**PLANNED UNIT DEVELOPMENT  
STAFF REPORT**

**Date: June 5, 2014**

**DEVELOPMENT NAME** New Hope Baptist Church.

**CONTEMPLATED USE** Planned Unit Development Approval to amend a  
previously approved Planned Unit Development to allow  
multiple buildings on a single building site and offsite  
parking.

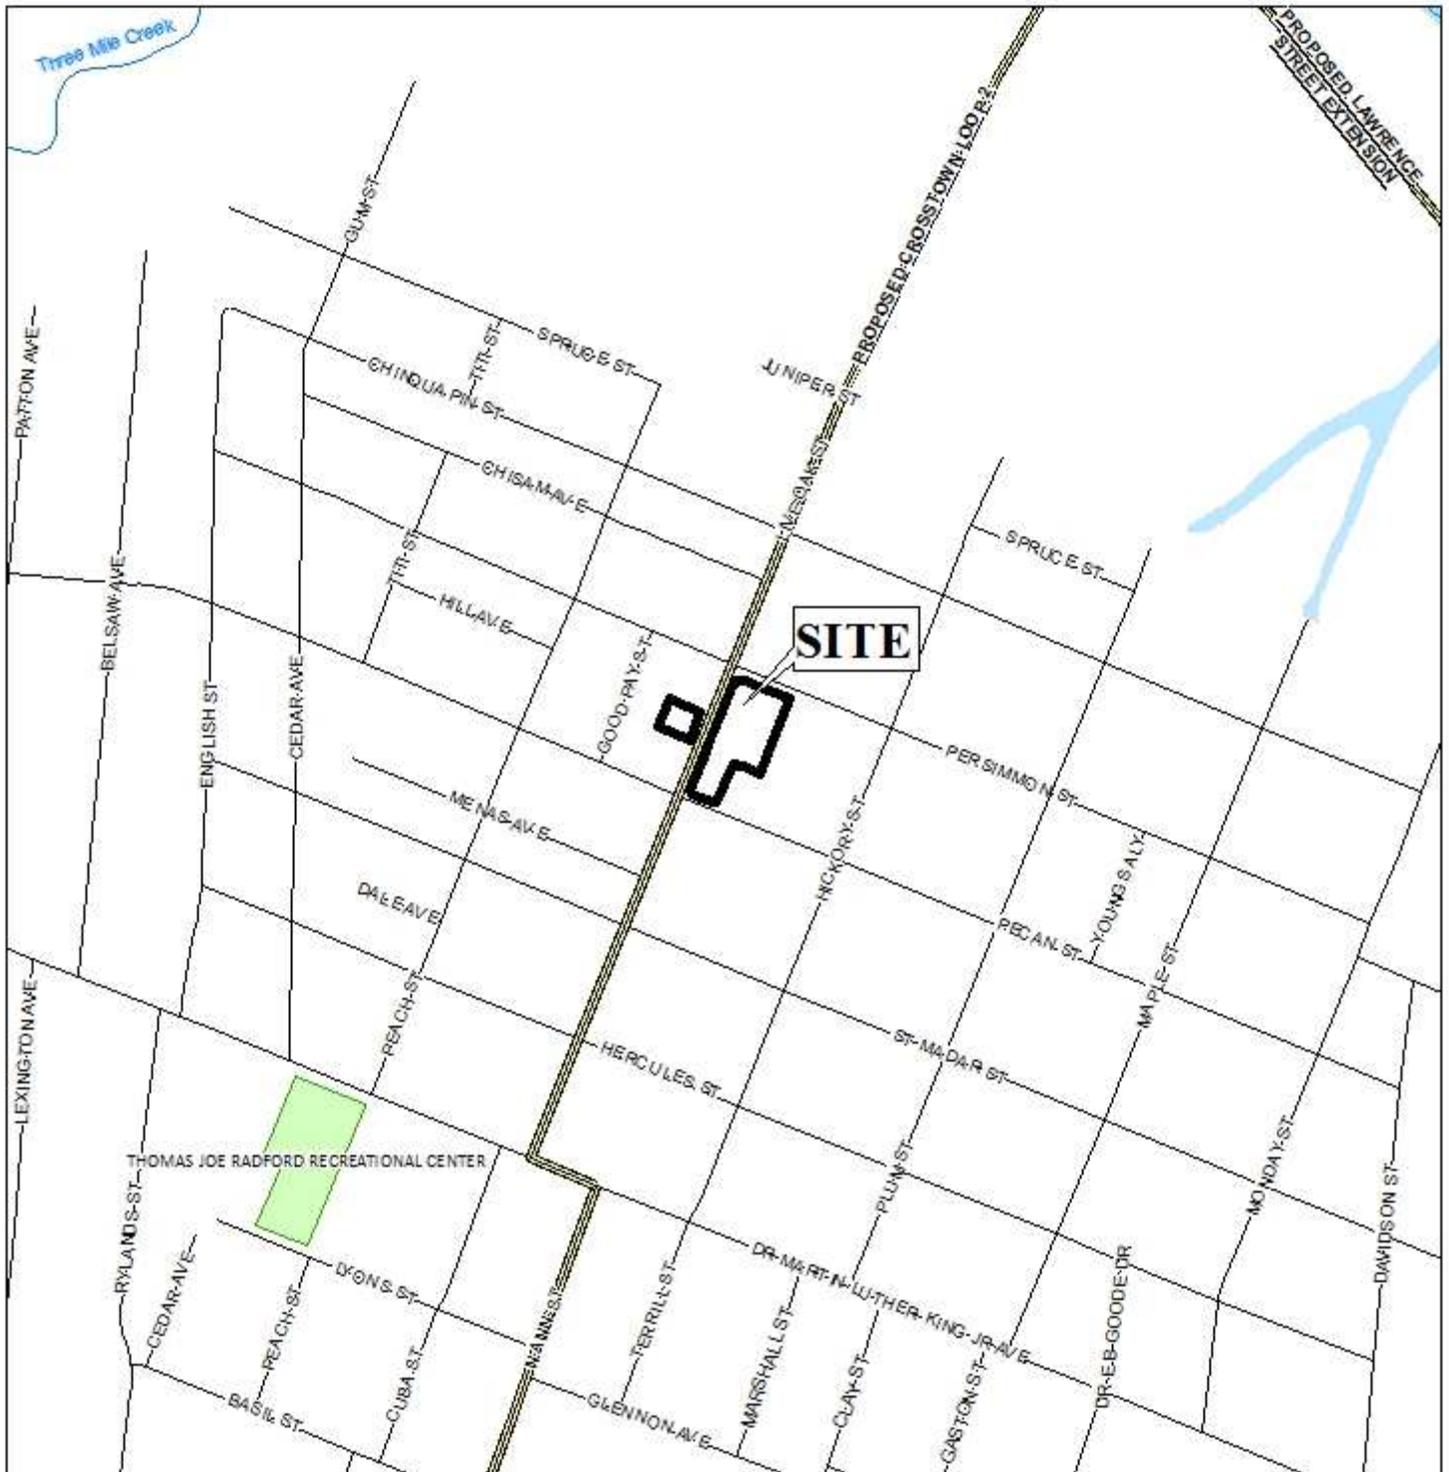
The proposed parking/access and maneuvering areas appear to be compliant, as it relates to the quantity and dimensions; however, only 2 accessible spaces are shown and no accessible route is depicted. Due to the size of the proposed sanctuary, the site would require 62 parking spaces, of which the building code (and Americans with Disabilities Act (ADA) require a certain percentage to be accessible parking spaces with one of every 6 accessible parking spaces being van accessible parking spaces according to the applicable building code section 1106 (and 2010 ADA Standards for Accessible Design). As such, the site plan should be revised, if necessary, to illustrate compliant number of accessible parking spaces and the required accessible route.

It should also be pointed out that the proposed covered drive-thru may reduce the access aisle width allocated for accessible parking, depending on where the posts are located.

It is important to note that lighting is not illustrated on the site plan. Any new lighting on the site will have to comply with the requirements of Sections 64-4.A.2., 64-6.A.3.c., and 64-6.A.8. of the Zoning Ordinance. A note reflecting this requirement should appear on the site plan, and photometric plans will be required at the time of permitting.

The site plan does not illustrate a dumpster on the property, however, there is a note stating that garbage collection will be via curb-side pick-up, which should be retained on the revised site plan.

In reference to vegetation, landscaping is illustrated on the site plan for the overall site, however, 11 overstory frontage trees and 6 crape myrtles appear to be proposed within 15' of above-ground utility lines. The applicant should keep in mind that any trees planted within 15' of above-ground utility lines **must** be live oak trees if overstory, or crape myrtles if understory. Therefore, the site plan should be revised to illustrate live oak trees, but if the applicant desires a different type of frontage tree, they should be depicted a minimum distance of 15' from the overhead utility lines.

It should be pointed out that due to the location of the proposed sanctuary and reduced setbacks, the applicant is proposing only 4 frontage trees along Live Oak Street, instead of the required 11 because of insufficient planting area. It is important to note that a Tree Planting Variance was granted by the Board of Adjustment; however, that tentative approval has also since expired. The applicant has, however, submitted a new application to the Board for tree planting, set to be heard at its June 2, 2014. If the variance request is denied, the site plan should be revised to

Finally, it should be noted that there was no signage information provided. The applicant should keep in mind that the location of any proposed sign structure, such as a monument or freestanding sign, should be illustrated on a revised PUD site plan, as PUD approval is site plan specific.

- 1) Revision of the site plan to illustrate a compliant number of accessible parking spaces and design compliance, to include an accessible route, with the requirements of the applicable building code section 1106 (and 2010 ADA Standards for Accessible Design);

- 2) Revision of the site plan to illustrate live oak trees within 15' of above-ground utility lines. All other frontage trees should be depicted a minimum distance of 15' from said utilities;

- 3) Revision of the site plan to comply with the frontage tree requirements of the Zoning Ordinance, if the Tree Planting Variance is denied;
- 4) Revision of the site plan to illustrate any proposed sign structure;

- 5) Retention of dumpster notes on the revised site plan;
- 6) Placement of a note on the site plan stating that any new lighting on the site must comply with the requirements of Sections 64-4.A.2., 64-6.A.3.c., and 64-6.A.8. of the Zoning Ordinance and submission of a photometric plan of the entire site at time of permitting;
